**DOCUMENT ID #:** 21-100007

**REVISION:** D-000

**DOCUMENT TITLE:** PACKAGE OUTLINE 156 BUMPS, WLP PKG. 0.5M

**CHANGE NUMBER:** 1180420

- DRAWING NOT TO SCALE - BOTTOM VIEW

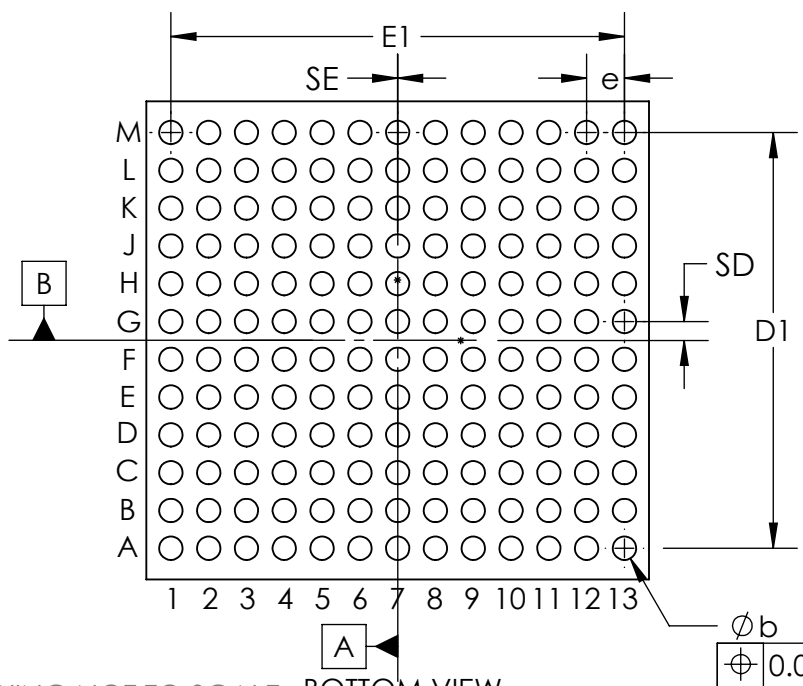
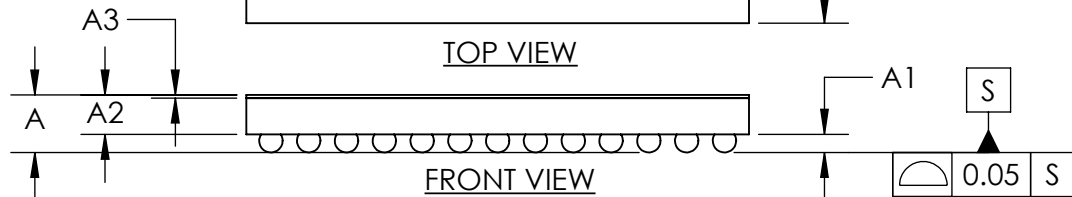
**REASON FOR CHANGE:**  
Remove "I" letter on the ball pin identifier

| REV | CHANGES MADE  | DATE     | INIT. |
|-----|---|----------|-------|
| D   | CN 1180420. Remove letter "I" in the ball pin identifier.                       | 02/07/23 | MA    |
